Housing Element Update

Final Environmental Impact Report
Responses to Comments on the Draft EIR

SCH#2022060323

June 2023

Figure 4.1-5a GUE-2 Looking North from Laughlin Road

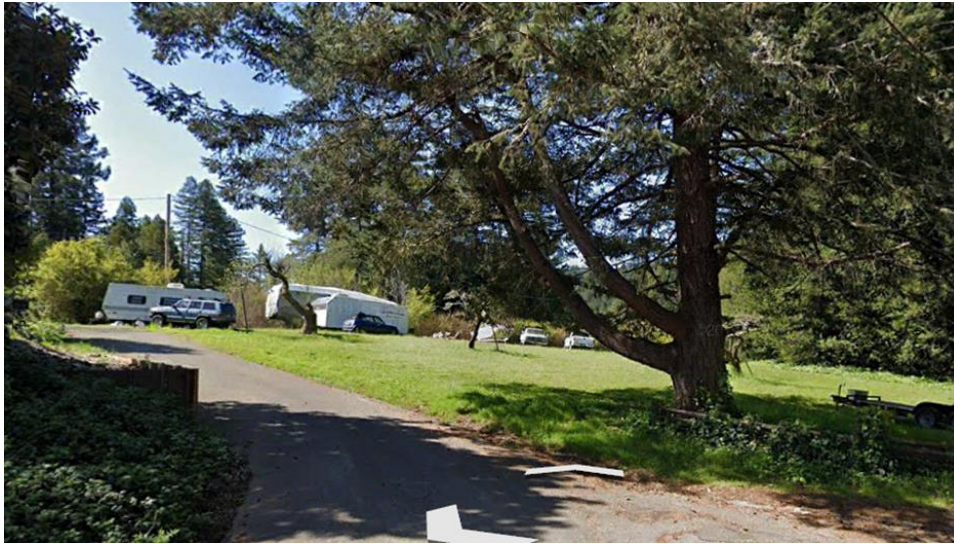
It is unclear which property the commenter is referring to; however, we presume that the commenter resides on Site GUE-2. Figure 4.1-5 on page 4.1-12 of the Draft EIR, and the preceding text describing Figure 4.1-5 on page 4.1-11 of the Draft EIR, have been revised as follows:

The commenter states Figure 4.1-5 of the DEIR is misleading since additional photos should show the immense valley view beauty which determines the visual character of Guerneville.

The commenter expresses the opinion that Figure 4.1-5 of the DEIR undermines the actual assessment of dominance in the area, and that the DEIR is missing a more in-depth and local view of the area.

GUE-2 and GUE-3 are on largely undeveloped lands among single-family residences bordered by agricultural lands and wooded hillsides (Figure 4.1-5a and Figure 4.1-5b).

The commenter's opinion is noted; however, Figure 4.1-5 is intended to provide views of GUE-2 and GUE-3 that is experienced by travelers on Cutten Road, and not views experienced by residents or visitors on GUE-2 or GUE-3.

The images provided in the Draft EIR are not exhaustive of the analysis conducted in the Draft EIR. Additionally, Figure 4.1-5 does provide a perspective of a clearly visible redwood tree. Redwood trees are prevalent in the area, and not located exclusively on GUE-3. Therefore, as described in Response 263.22, the EIR correctly characterizes GUE-3 as being co-dominant.

Page 2-17, Figure 2-9:

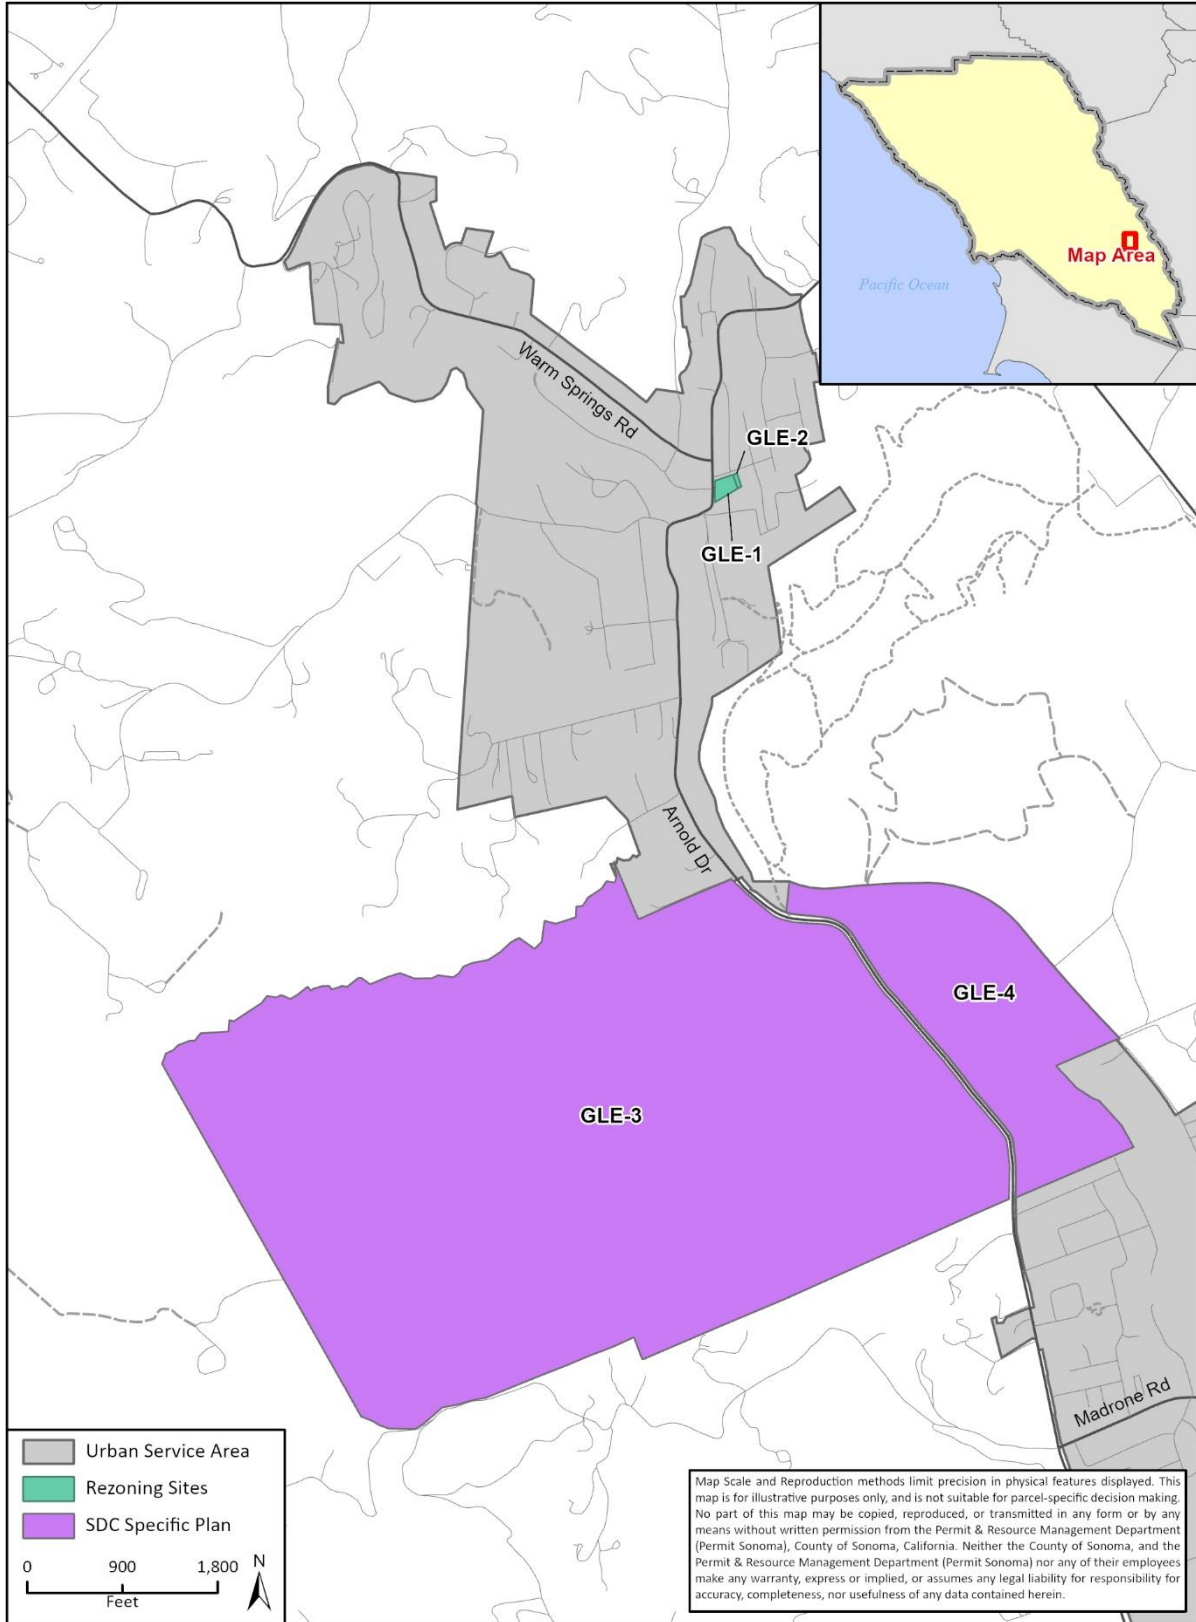
As shown in Figure 2-9 on page 2-17 of the Draft EIR, Sites GLE-1 and GLE-2 are within a designated Urban Service Area. Additionally, page 2-6 the Draft EIR has been revised for clarity, as there was a typographical error:

(figure removed)

Figure 4.10-9 FEMA Floodplain Map – Larkfield

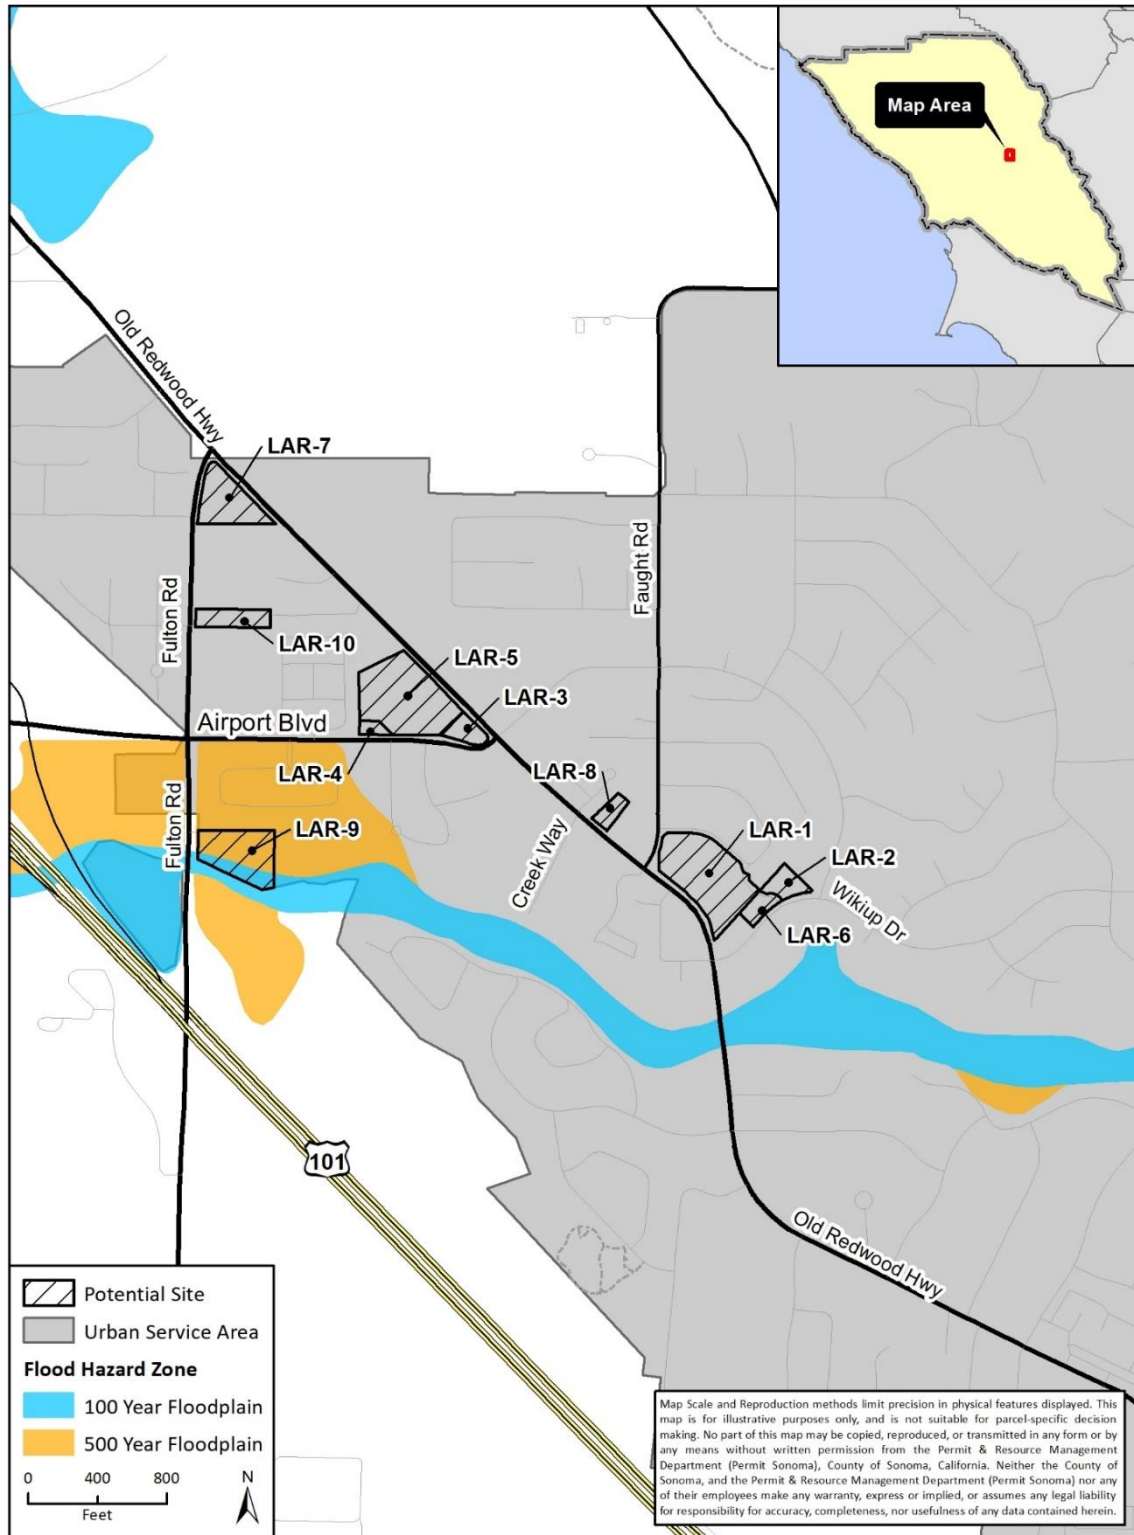
The commenter is correct, and Figure 4.10-9, which shows that LAR-9 is partially within both a 100-year and 500-year flood zone has been added to the Draft EIR. These revised figures are included in Section 5 of this document. Additionally, the following revisions have been made throughout Section 4.10 of the Draft EIR to reflect inclusion of LAR-9 in the flood analysis:

The following figure is added immediately preceding page 4.10-15:
